# REVIEW OF VICTORIAN NORTH EAST RAIL LINE UPGRADE PROJECT TO ACHIEVE V/LINE PASSENGER CLASS 2 TRACK GEOMETRY

Report No: Monash/RT/2018/1361

**March 2019 (Revised Final)**

FIGURE 1: DETAILED CONDITION DATA UTILISED BY ARTC IN DEVELOPING THE NERL UPGRADE PLAN

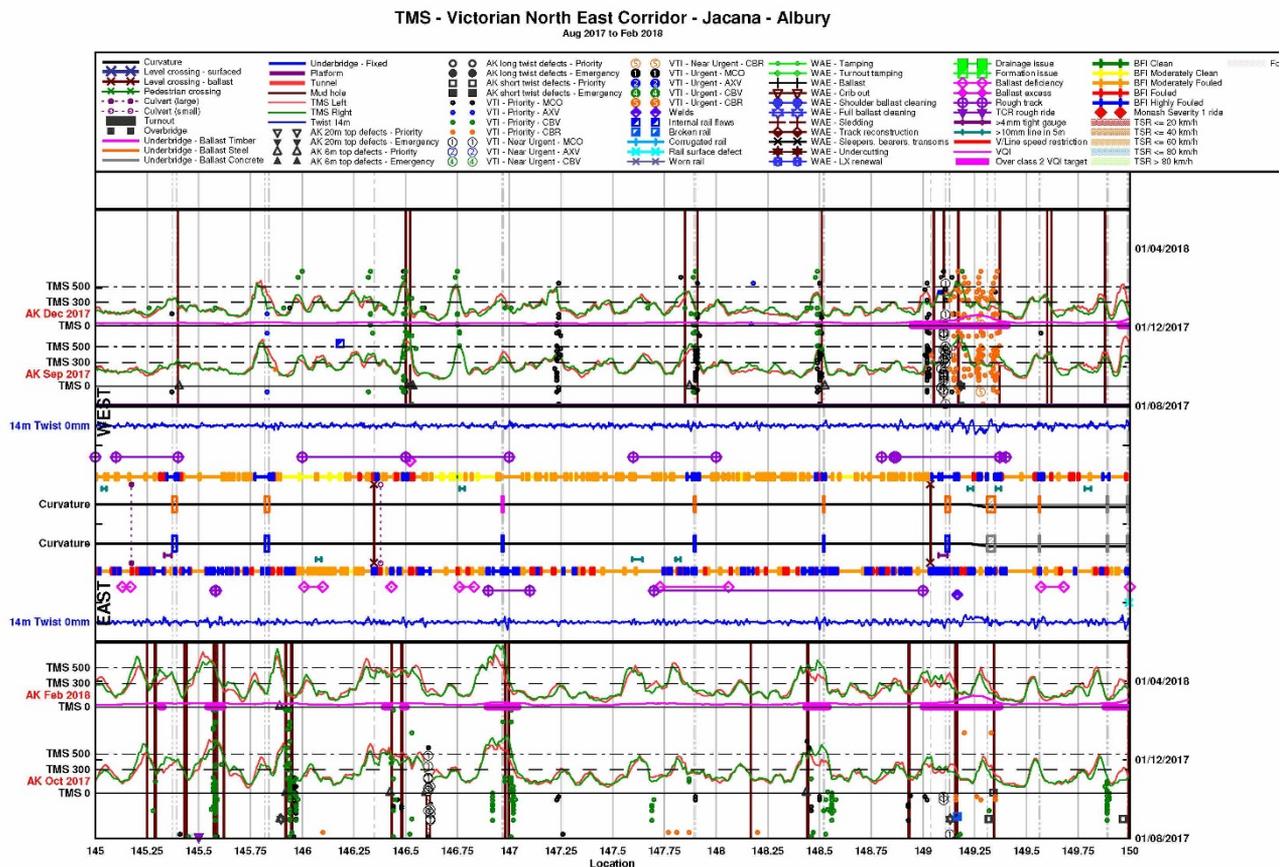
ARTC clearly note that any upgrade should be condition-based. Current information used by ARTC to feed into the analysis methodology include the TMS and VTI hits, complemented by field inspection data. It is noted that whilst these inspections are now complete, the plan provide to IRT for review did not include the most recent assessments. TMS was the main source of the information used to assess the condition of the track and the ‘first pass’ allocation of work activities; VTI hits were principally used to evaluate the condition of level crossings and bridge ends. Additional information, an example of which is shown in Figure 1, was used by ARTC to support/verify the final plan.

FIGURE 2: INSTRUMENTED REVENUE VEHICLE DATA (RIDE COMFORT) OVERLAYED AGAINST ARTC MUD HOLE LOCATIONS AND TMS500 PEAK LOCATIONS.

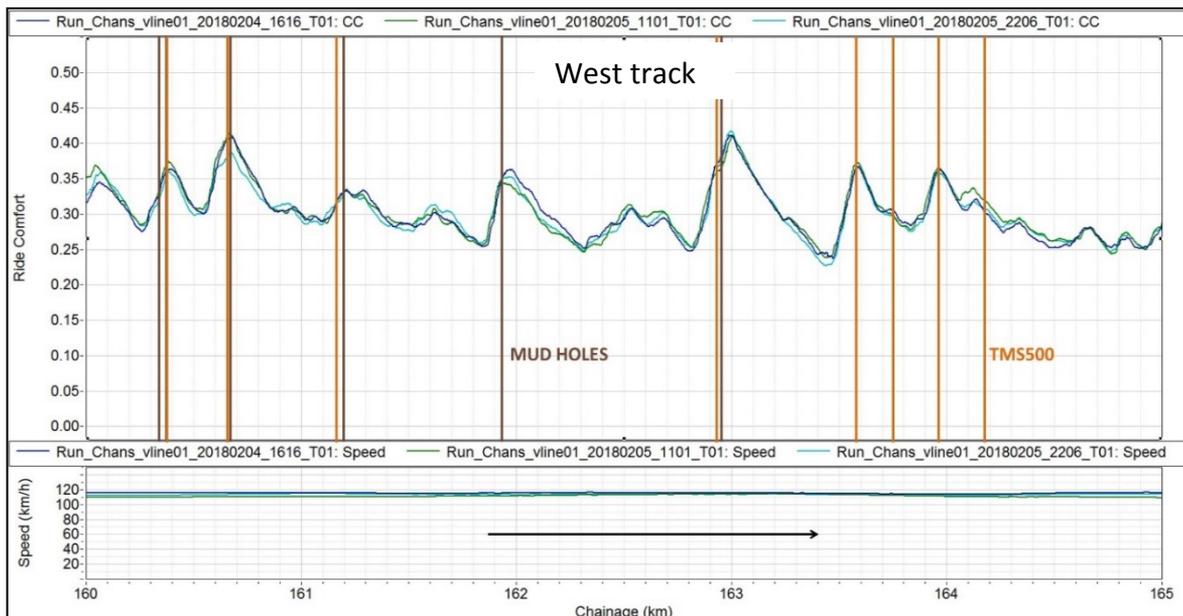
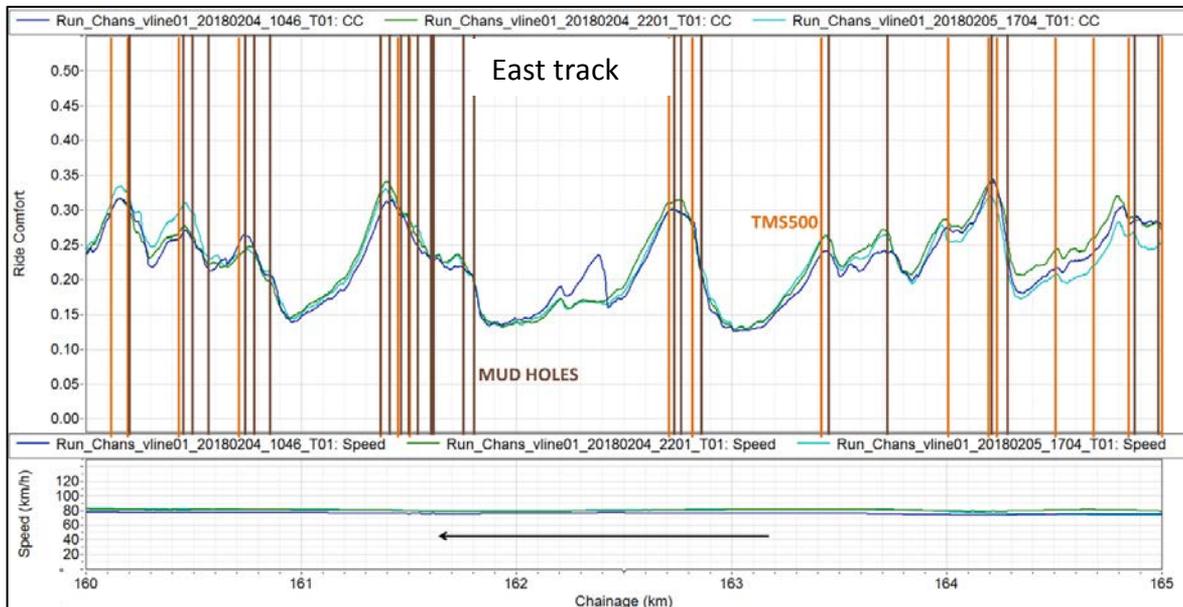
An example of the IRV response (3 runs overlaid) over a 5 km track section of both the East and West line between Violet Town and Euroa is shown in Figure 2. It is worth noting that there is currently a speed restriction of 80 km/h imposed on the East line, but no speed restriction has been applied to West line. For this section of track, ride comfort metrics are slightly lower (i.e. better ride) on the East line, most likely due to the imposition of the speed restriction (i.e. lower response due to lower speed). Also shown in Figure 2 are the locations of mud holes (vertical brown lines) taken from the ARTC Ellipse data base, as well as TMS500 exceedance locations (vertical orange lines) from the track geometry recording car. As can be seen, these results show relatively good correlation between the TMS exceedance versus mud hole locations and the high IRV ride comfort index locations, irrespective of the imposed speed restrictions.

FIGURE 3: TMS vs. VQI.

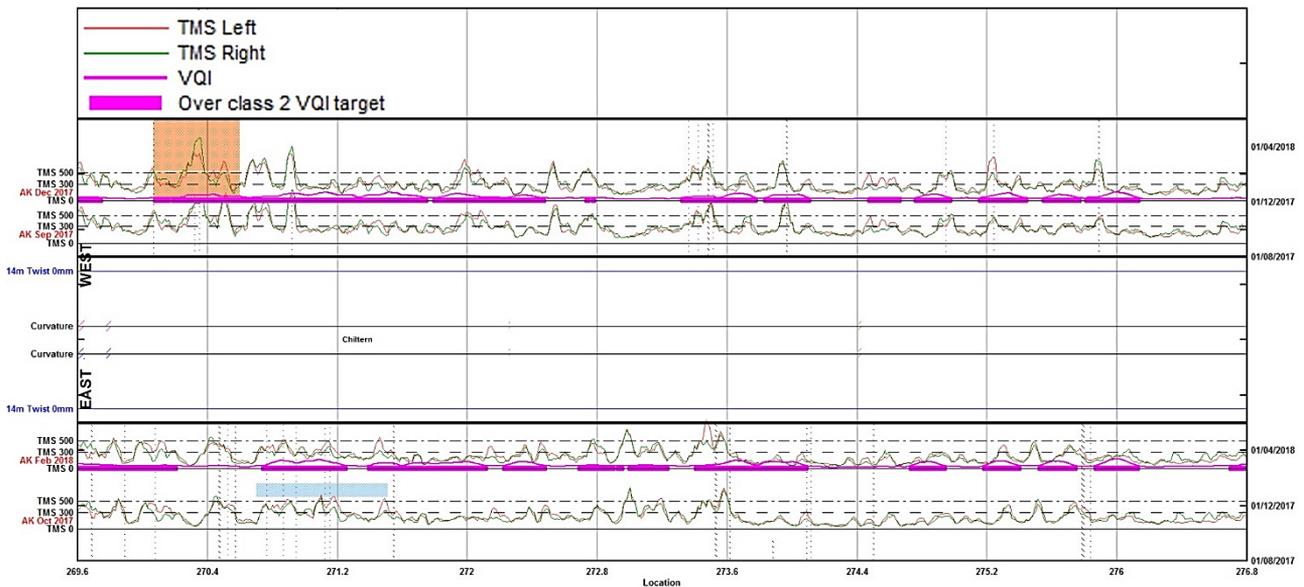
Figure 3 shows a sample of the TMS data provided by ARTC. This plot also includes additional details of the estimated VQI (preliminary results) and highlights locations where VQI values are over V/Line Passenger Class 2 limits. As was the case with the IRV data, from these preliminary results a reasonable match of VQI peaks with TMS maxima was apparent.

FIGURE 4: TAMPING AND UNDERCUTTING HISTORY ON EAST TRACK (TOP) AND WEST TRACK (BOTTOM) FROM ARTC.

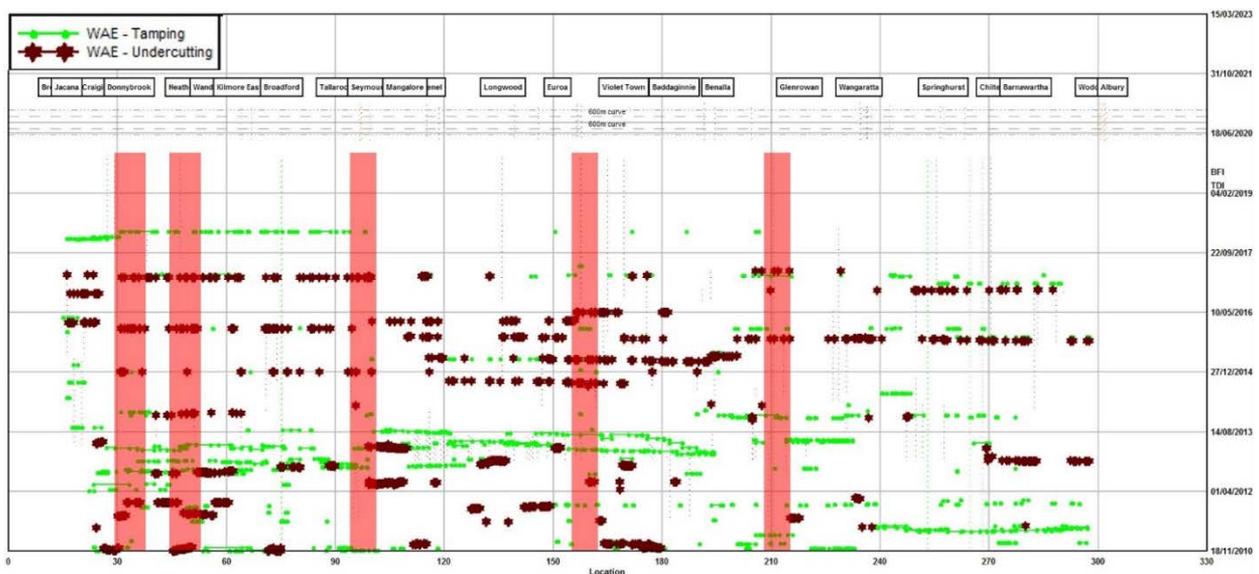
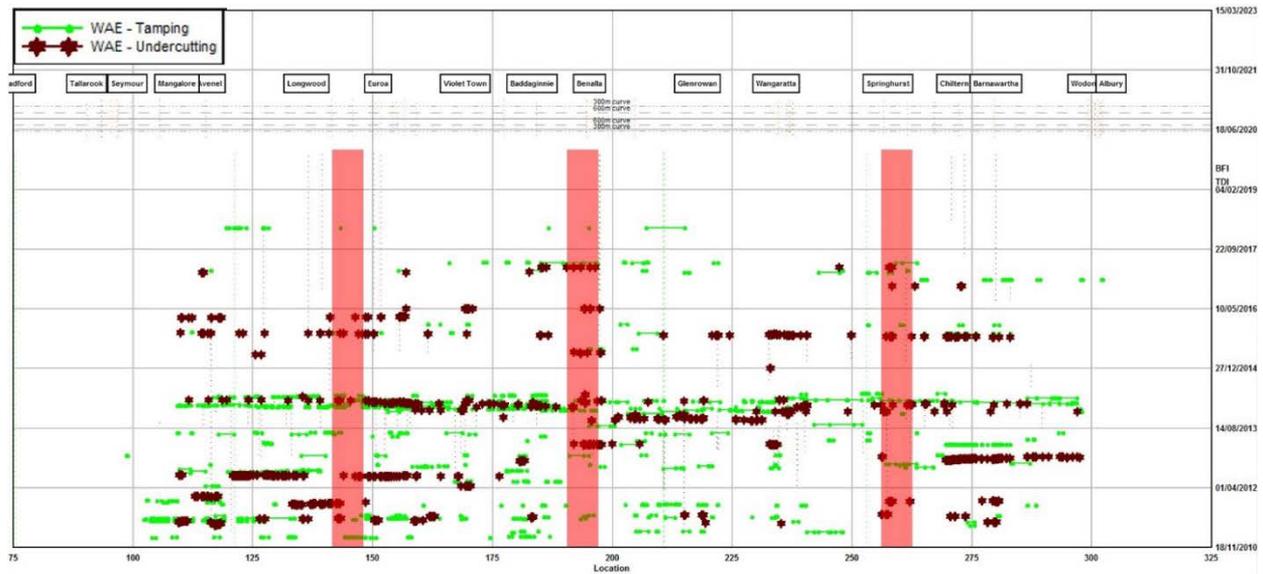
Figure 4 shows the tamping and undercutting maintenance record provided by ARTC from 2011-2018 (y-axis on the right). It should be noted that the local maintenance activities performed by ARTC local gangs are not input into the ARTC database and not available to aid this review. Some typical locations (shaded red) required revisiting for tamping and lining as well as undercutting activities. If the records from the local teams were included, a more comprehensive picture of the network maintenance requirements would emerge. The detailed site inspections recently completed by ARTC (but not available for this review) should focus on similar such locations using the maintenance history as a basis. The locations which required extensive repetitive maintenance works would possibly indicate underlying formation or drainage issues which could not be fixed by the simple ballast depth improvement and subsequent tamping and lining proposed in the ARTC upgrade plan. It is important that these locations (i.e. high historical maintenance requirements or regions with continual poor geometry) be identified and corrected as part of the upgrade plan to ensure that these do not continue to be ‘maintenance hot spots’ locations into the future. Whilst all track will receive additional ballast together with tamping and lining, these locations may require more effort dependent upon the individual findings from the track inspections.
